Addendum No. 01

Subject: Andrew J. Morrison Elementary School – Fire Alarm System Replacement
SDP Contract No. B-009 (C) of 2017/18

This Addendum 01, dated January 30, 2018 shall modify and become part of the Contract Documents for the work of this project. Any items not mentioned herein, or affected by, shall be performed strictly in accordance with the original documents.

DRAWING NO.
E601

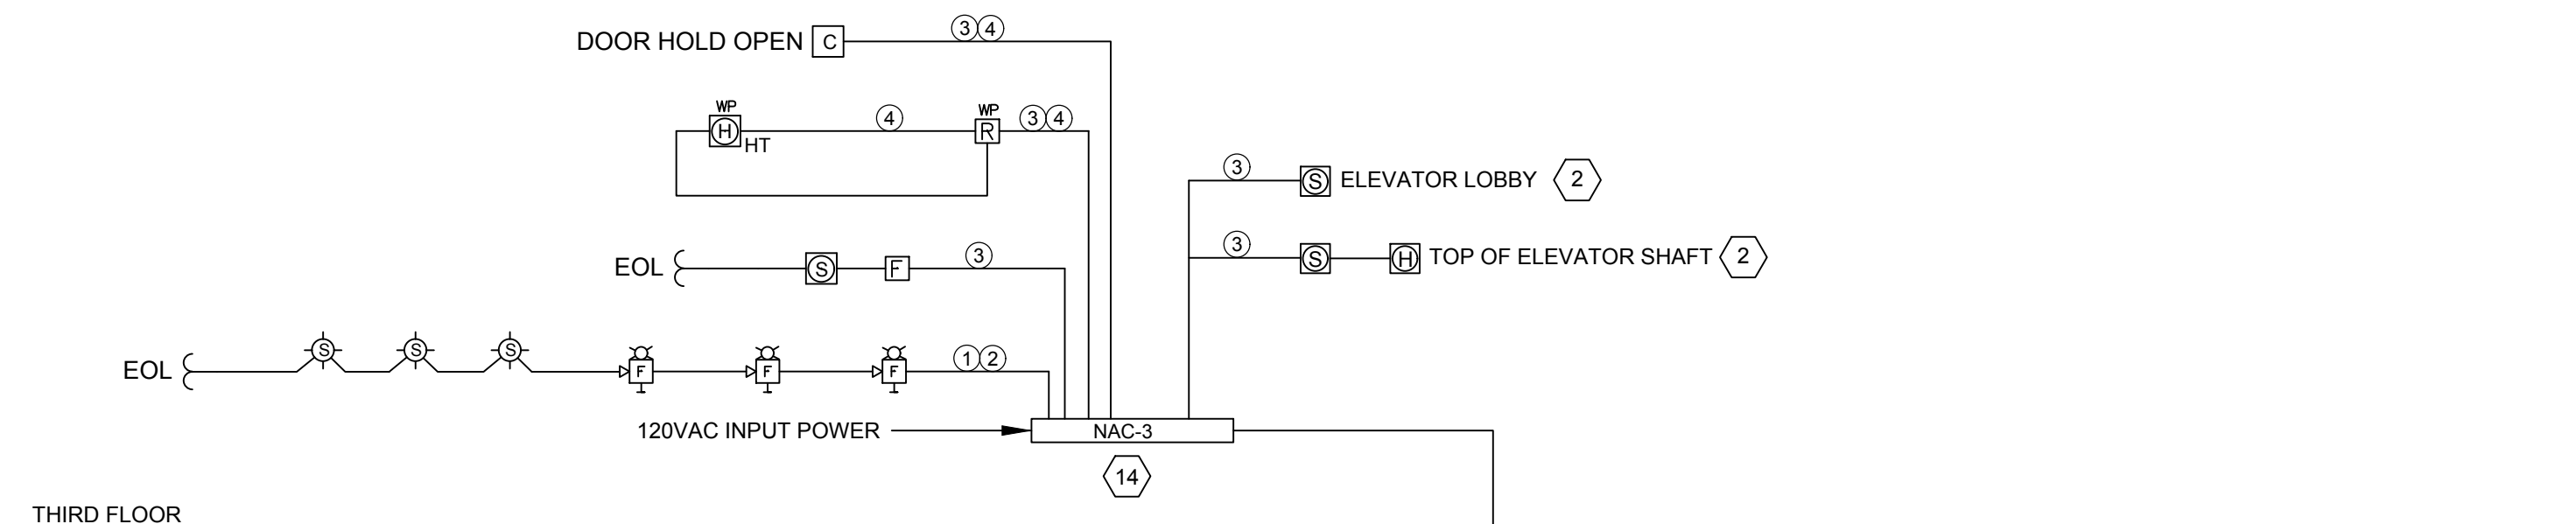
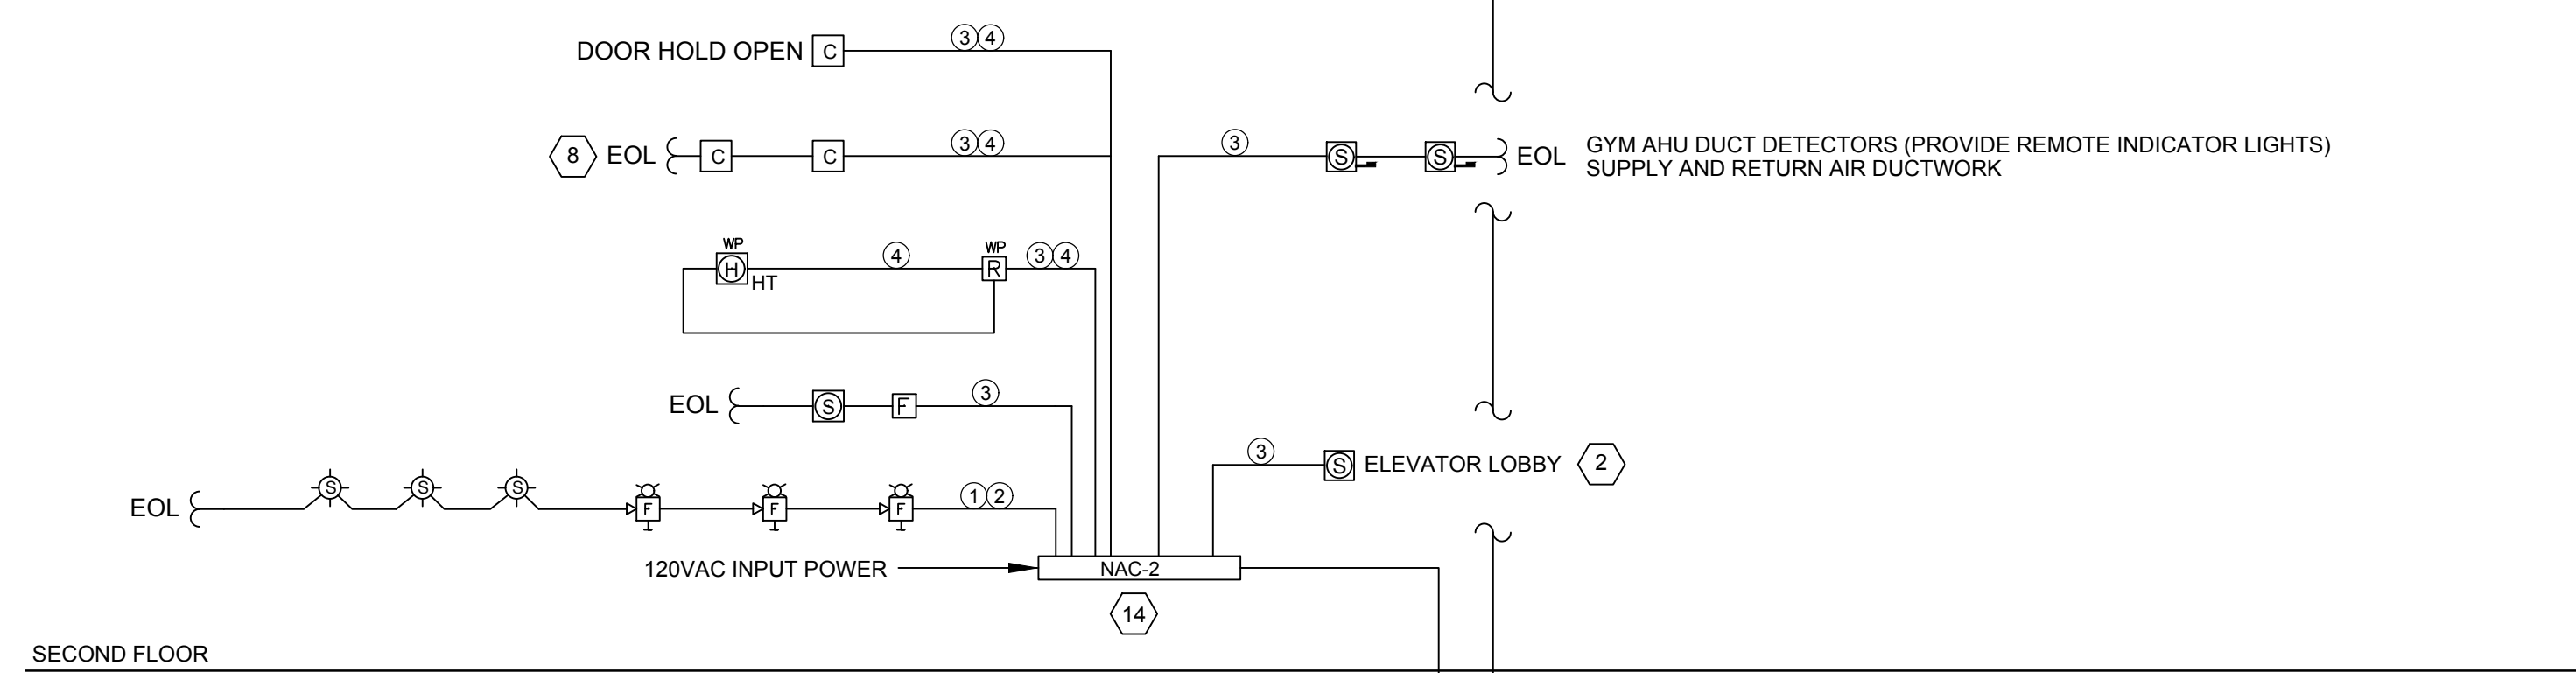
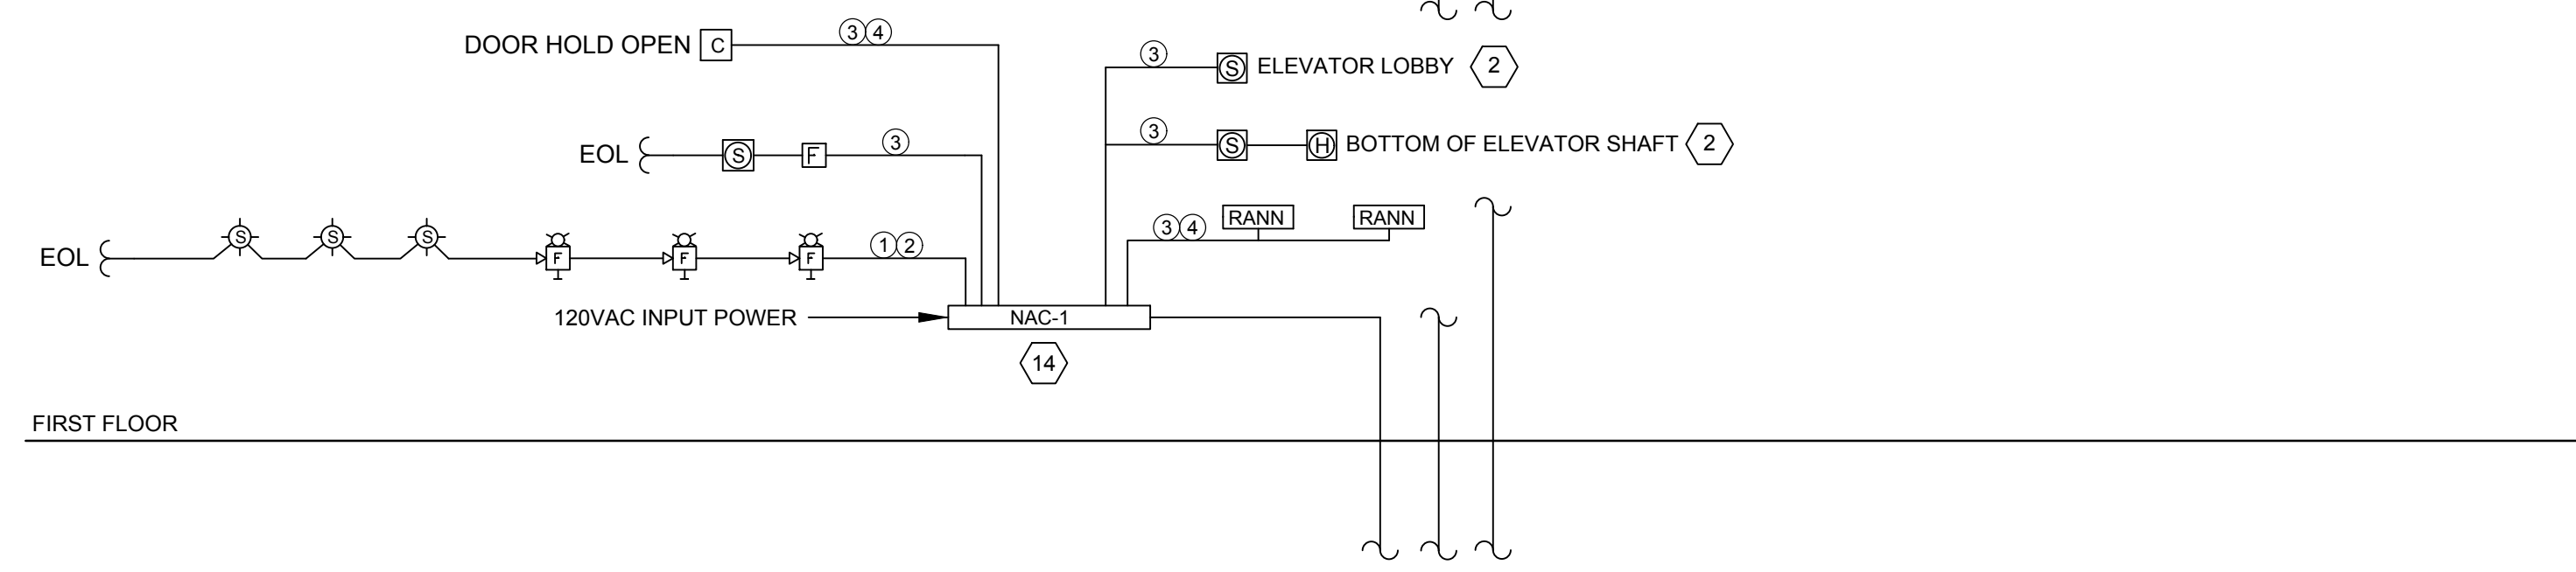
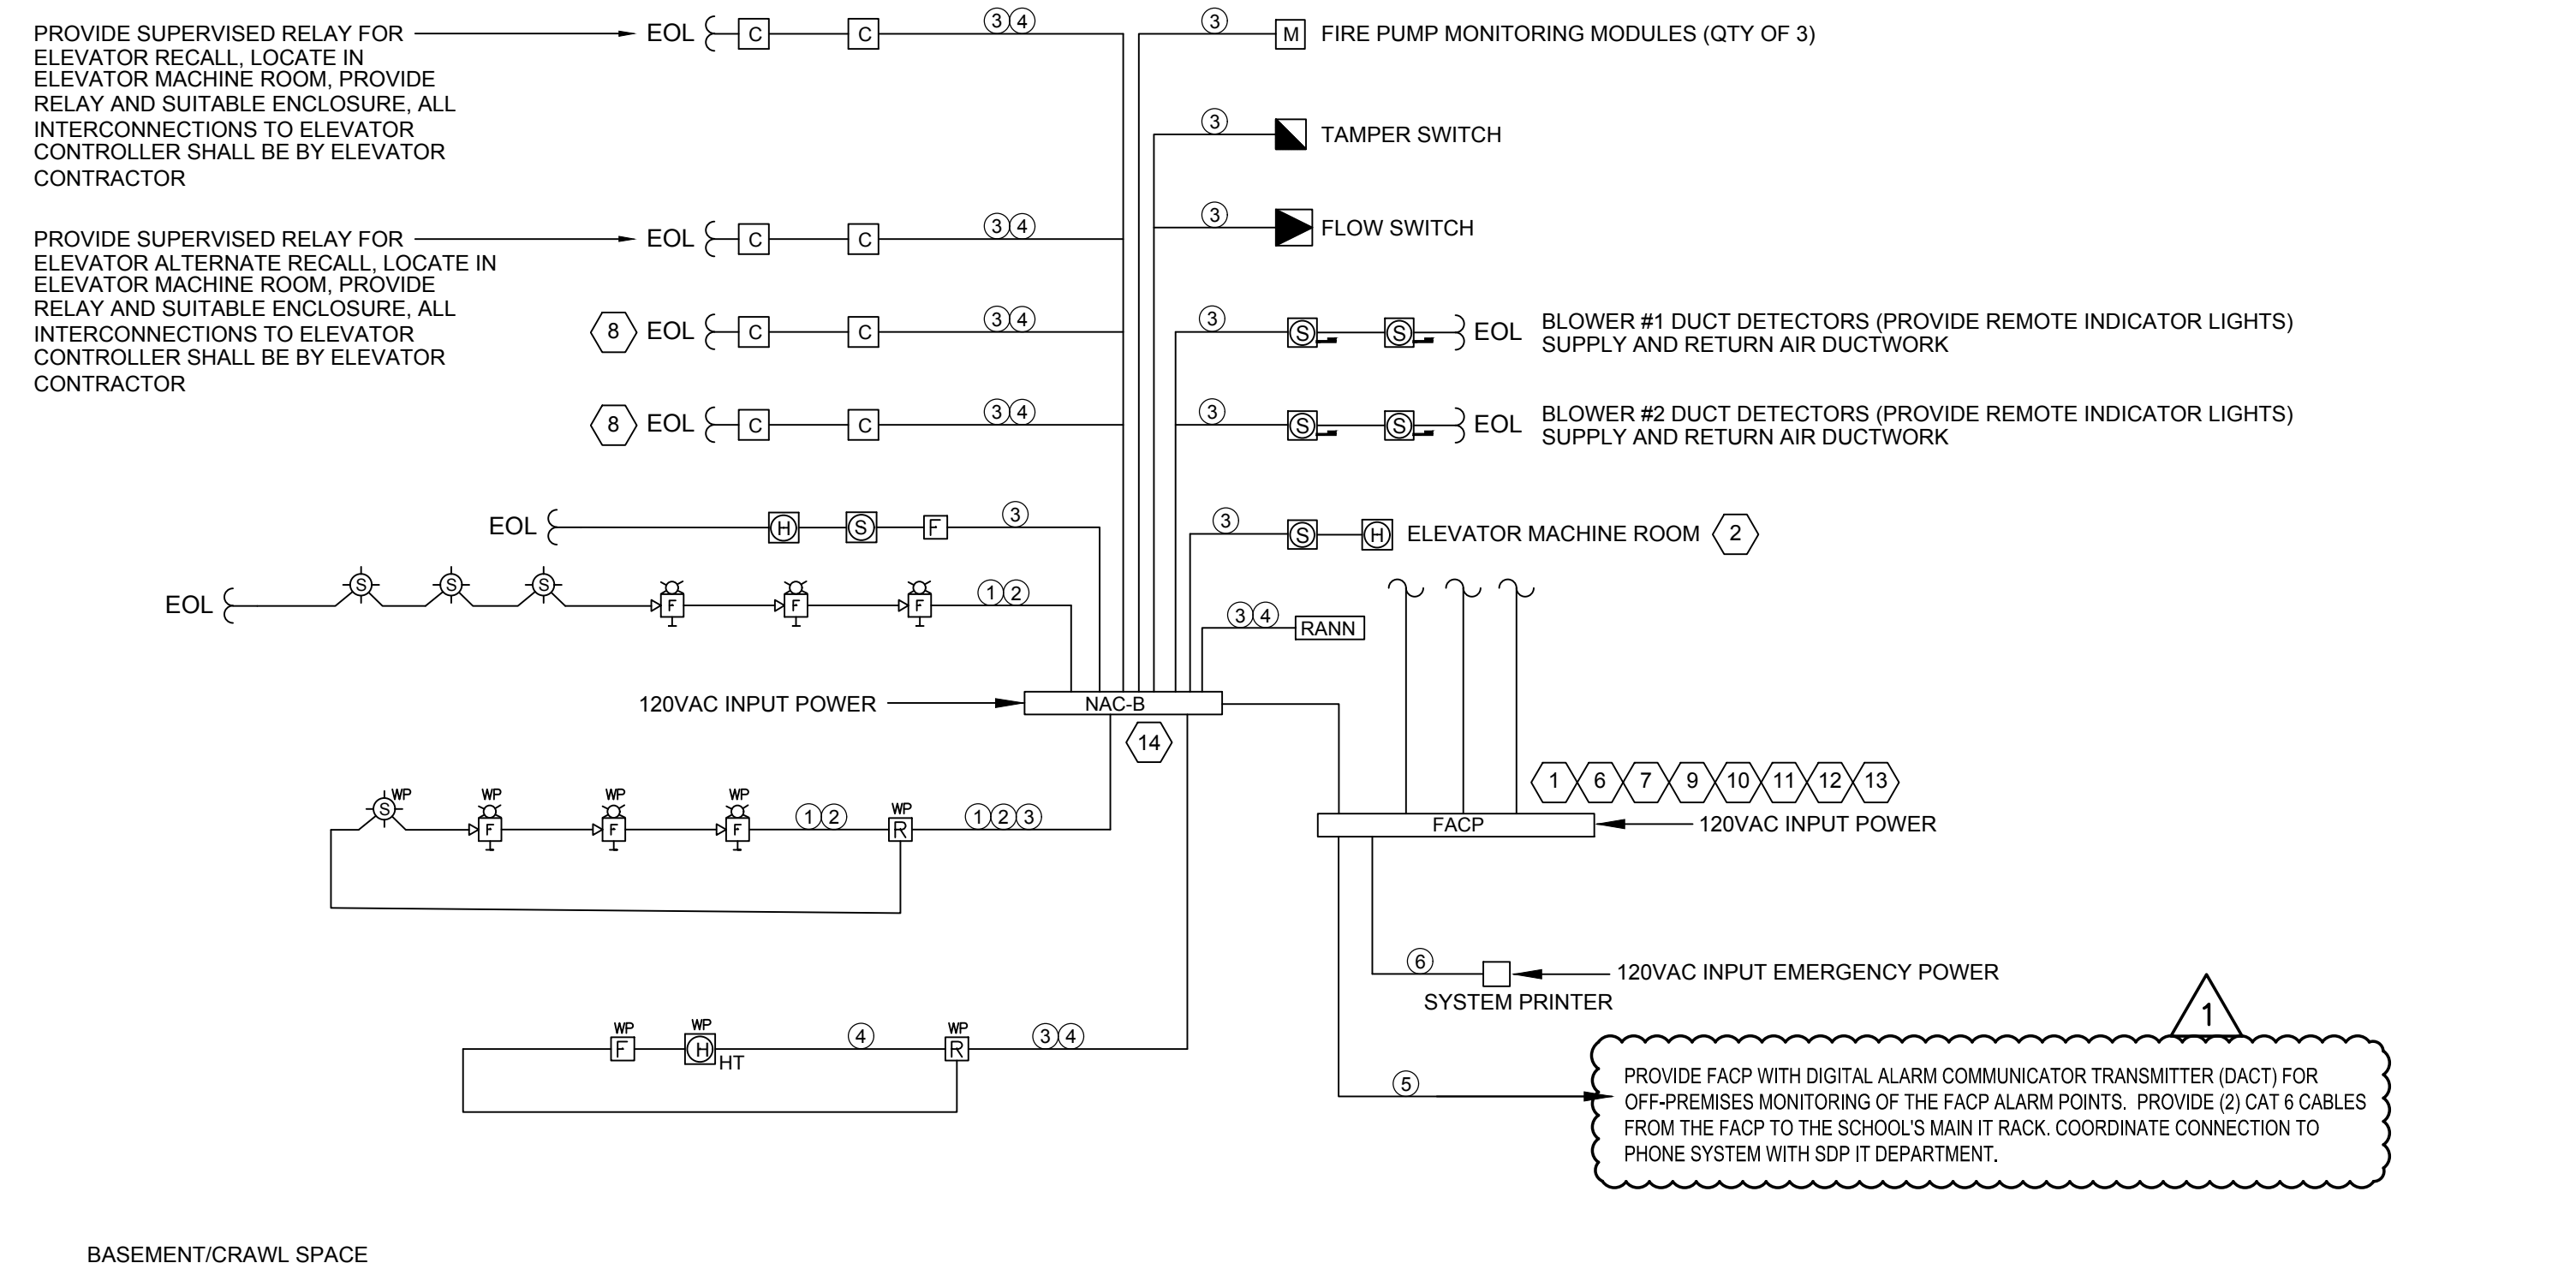
Drawing E601 – Revised the Fire Alarm System Riser, removed requirement for (2) copper telephone lines to FACP.

DRAWING NO.
E602

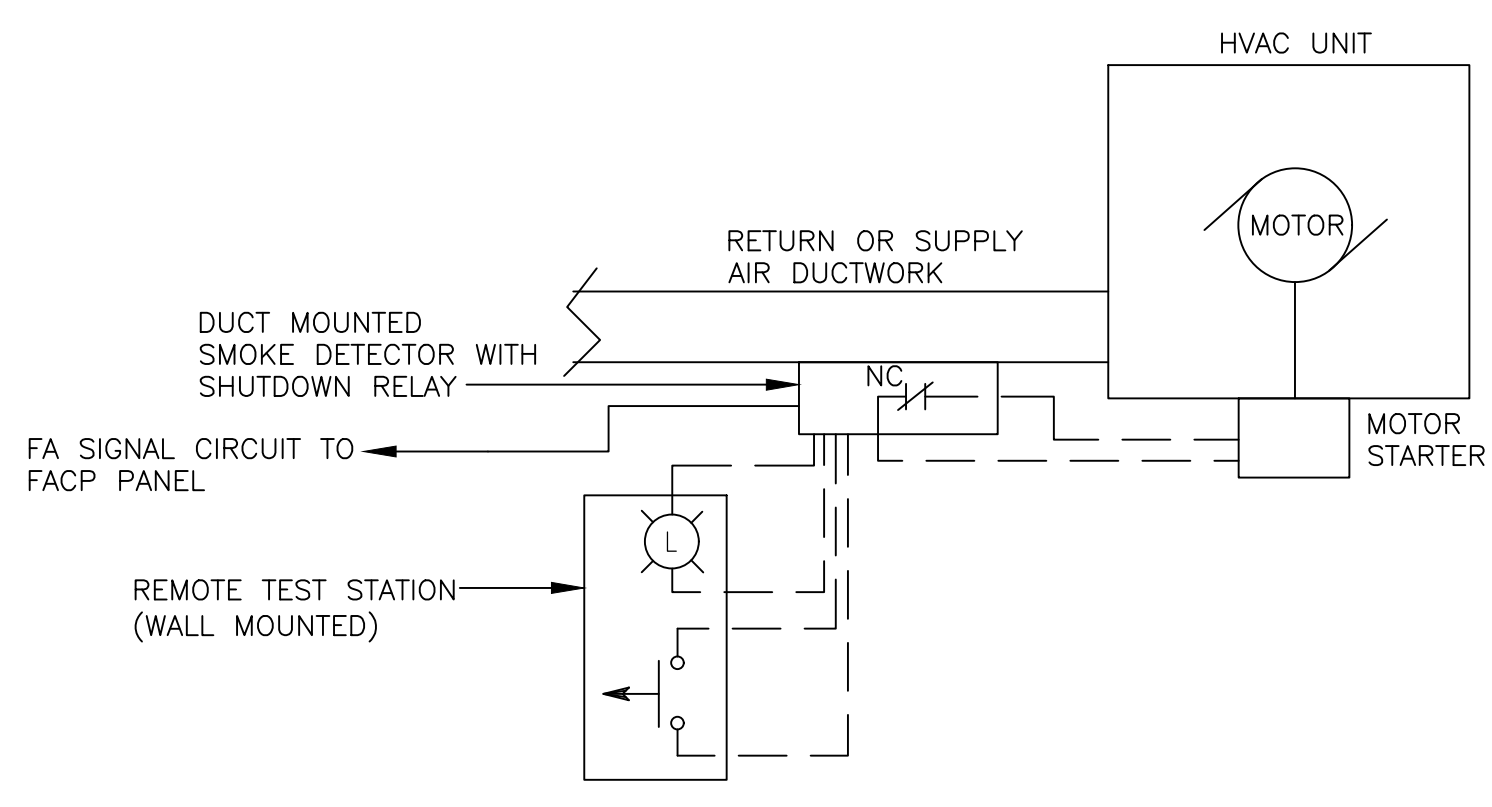
Drawing E602 – Removed Motor Schedule.
